| FHWA REGION NO. | STATE | PROJECT NO. | YEAR | SHEET NO. | TOTAL SHEETS |
|---|---|---|---|---|---|
| 7 | KANSAS | 54-87 K-6657-01 | 2002 | 658R | 1122 |

**ADDENDUM NO. 2:**
The following changes and additions shall be made to the plans and proposal. When this addendum conflicts with the specifications, plans, or special provisions, or Addendum # 1, **THIS ADDENDUM SHALL GOVERN**.

**Sheet 658**

# TRAFFIC SIGNAL PLAN
# KELLOGG & MAIZE ROAD
# WIRING DIAGRAM

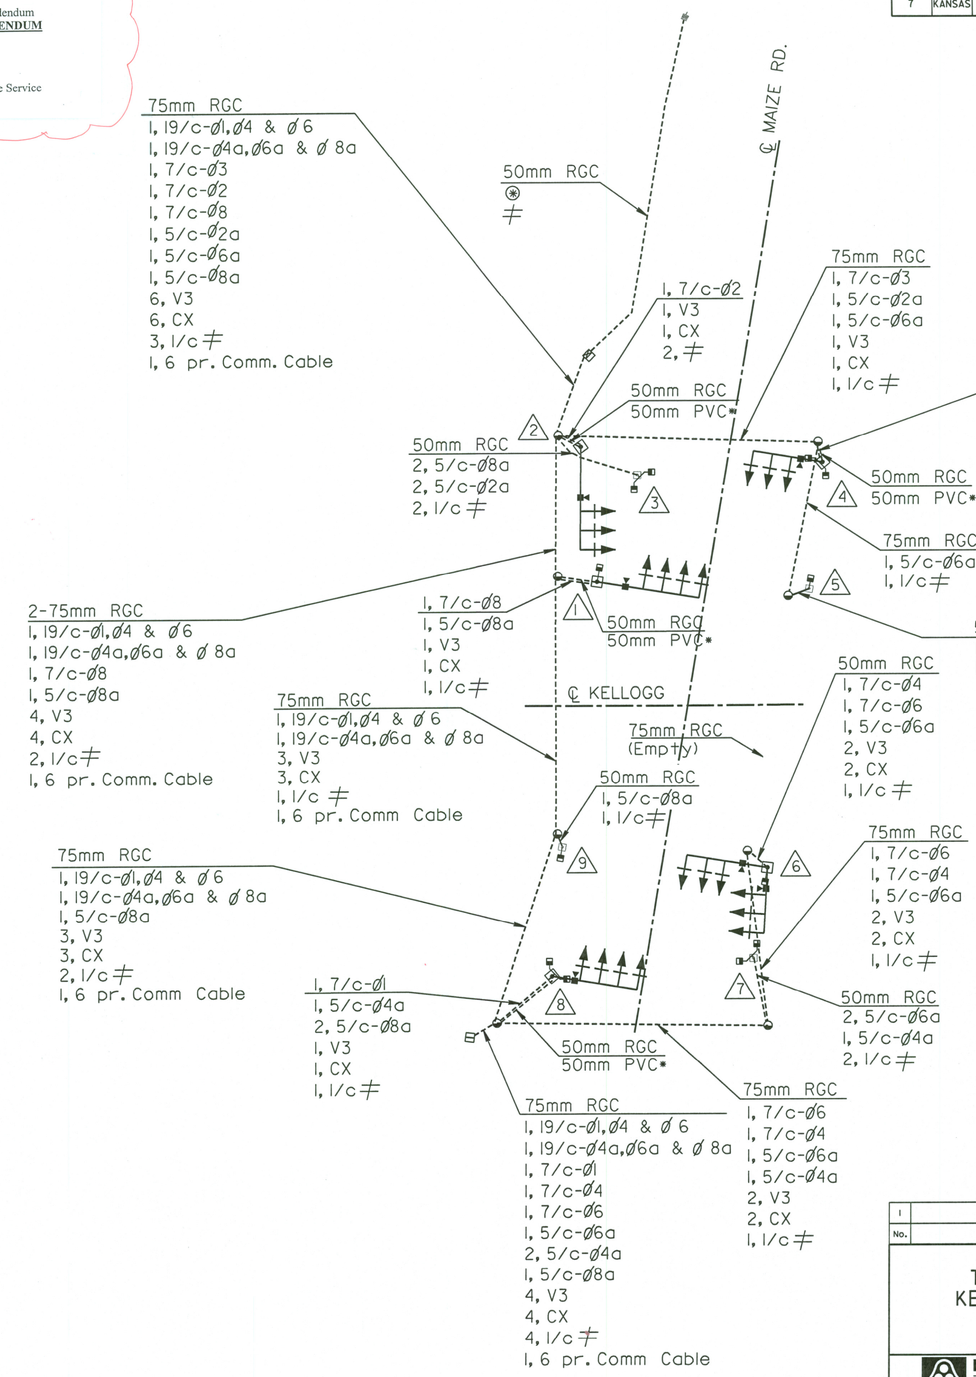
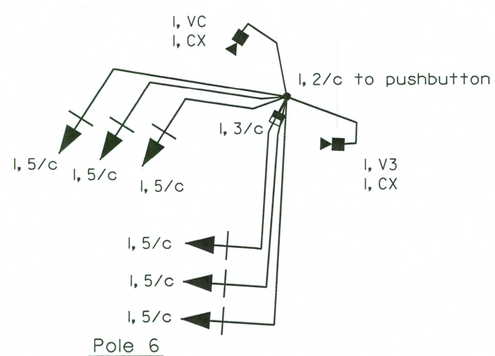
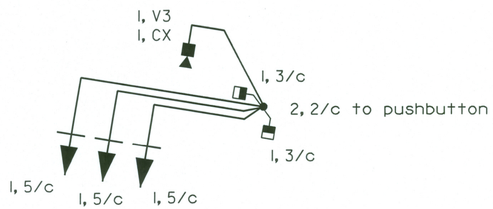
1. Add a single 50mm PVC conduit from the Service Box at Sta. 15+598, 13m Lt. to the Service Box at Sta. 15+644, 11m Lt.
